**TELEDYNE
ENGINEERING SERVICES**

July 3, 1980
809-042

Subject: Comments on Proposed Criteria for Major Component Support Low-Alloy Bolting

Reference: NRC (Eisenhut) letter of May 20, 1980, Additional Guidance on "Potential for Low Fracture Toughness and Lamellar Tearing on PWR Steam Generator and Reactor Coolant Pump Supports", NUREG-0577.

FIGURE 1
 STRESS CORROSION LIMIT
 LOW ALLOY BOLTING

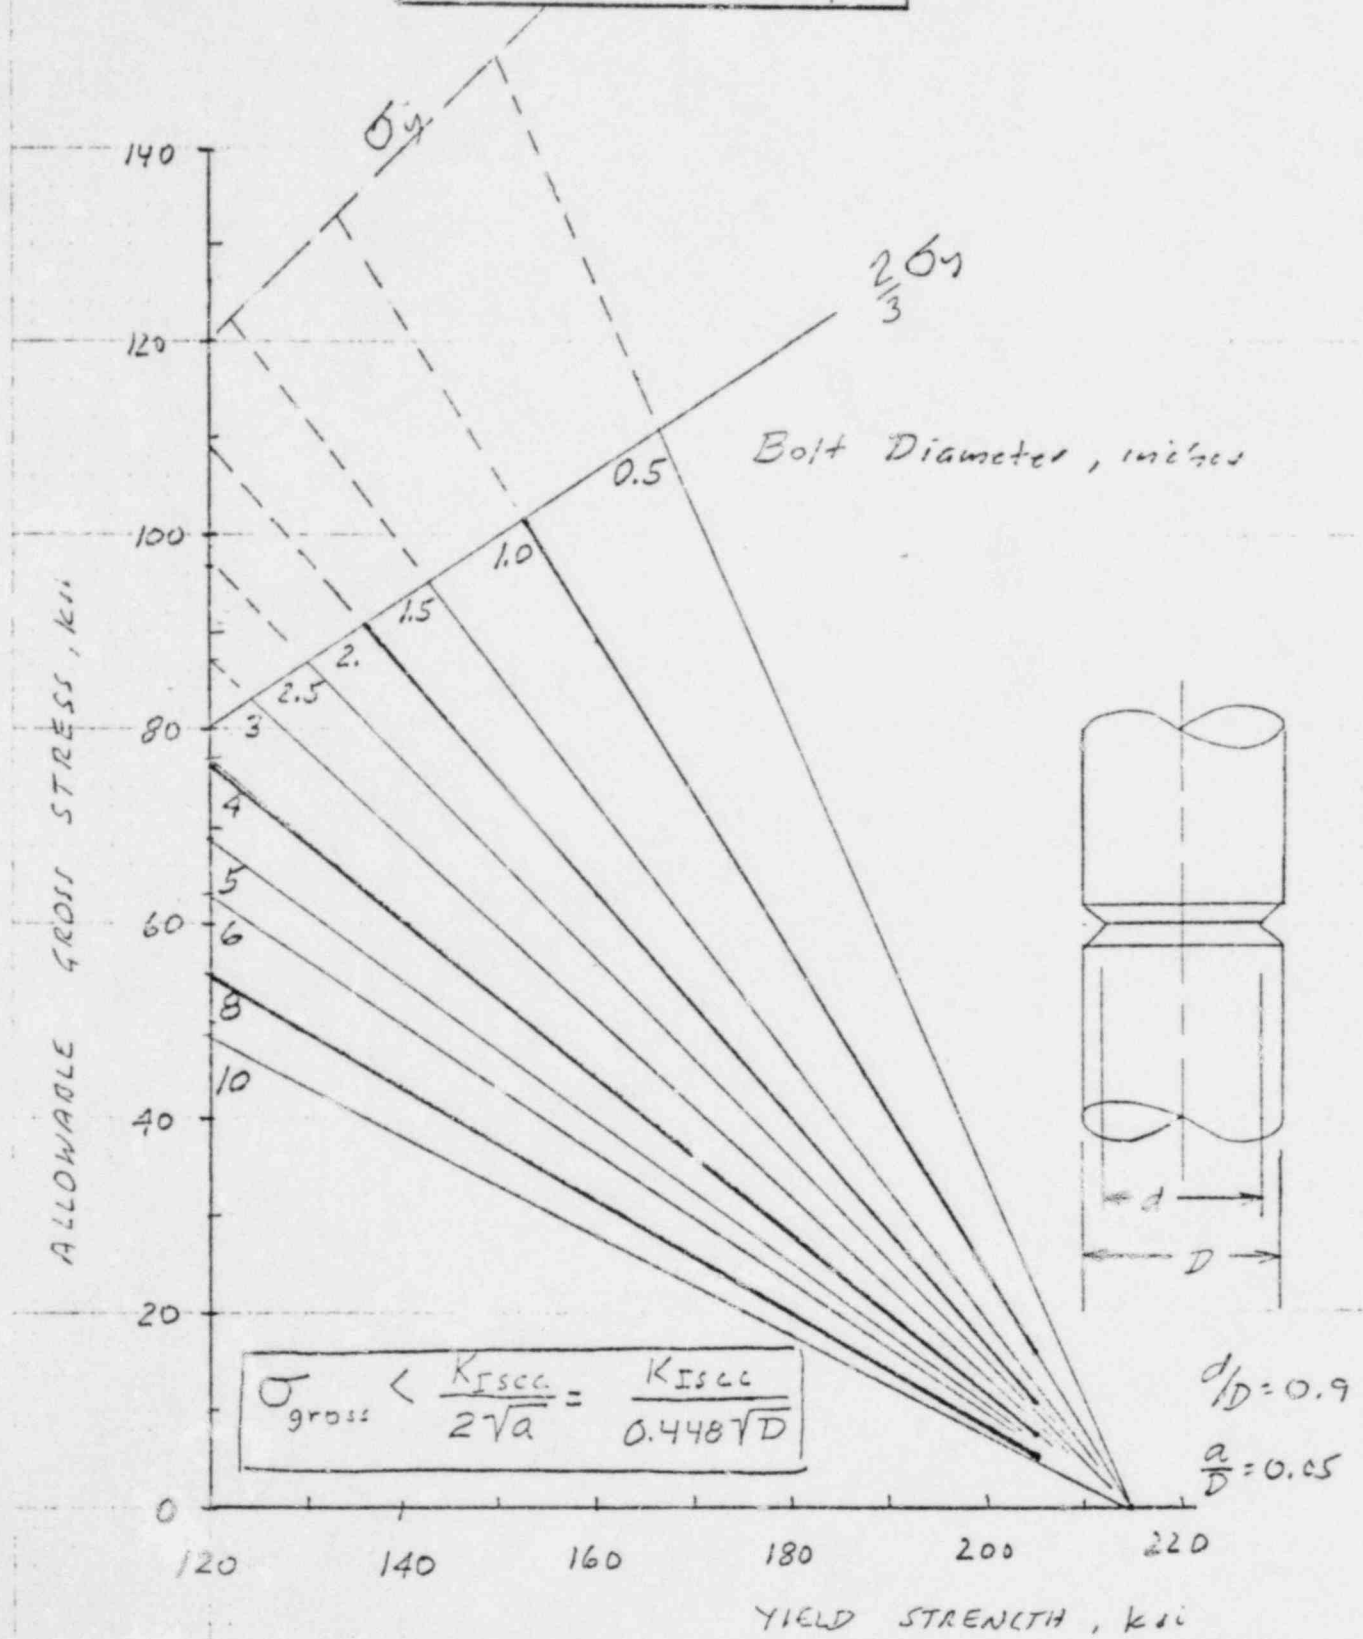
The latter point is illustrated by Figure 1 which applies the NRC material property curve to the defined flaw. At yield strengths below 120 ksi, the allowable stress is independent of diameter and increases as the tensile properties increase. With the flaw defined as a function of diameter, the allowable stress at yield strength in excess of 120 ksi is dependent upon diameter and decreases as the yield strength increases. A step decrease in allowable stress is indicated by Figure 1 for bolt diameters greater than 3.7" as the yield strength increases from just below 120 ksi to just above 120 ksi. With the parameters used on this Figure, use of a maximum annular crack depth of 0.2" would essentially eliminate this discontinuity, in that the curve labeled "4" would apply to bolt diameters 4" and greater.

Experience indicates that stress corrosion cracking becomes of concern in AISI 4340 material for properties in excess of 180 ksi yield strength, 200 ksi tensile strength or hardnesses above 43 HRC. The NRC proposed procedure forces concern at yield strengths lower than 180 ksi for bolts of diameter larger than 0.5 inches. This result comes about not necessarily because of the K_{Isc} curve adopted by NRC, although it is a lower bound, but because of the very large defect size which NRC requires to be postulated. The previous TES recommendation with respect to maximum flaw depth, 0.2", was based on considerations other than the physical source of the initial defect. Therefore, TES further recommends that NRC consider a reduction in the maximum postulated flaw depth on the basis of the physical source of such initial flaws. It is expected that a depth of 0.02" may be appropriate.

However, TES recommends that the postulated flaw be defined as a function of diameter only up to some maximum value of flaw depth. Specifically, TES recommends that the words "assuming a 1/10 T flaw" be replaced with the words "assuming a complete circumferential flaw of depth equal to 0.05D but not to exceed a flaw depth of 0.2".
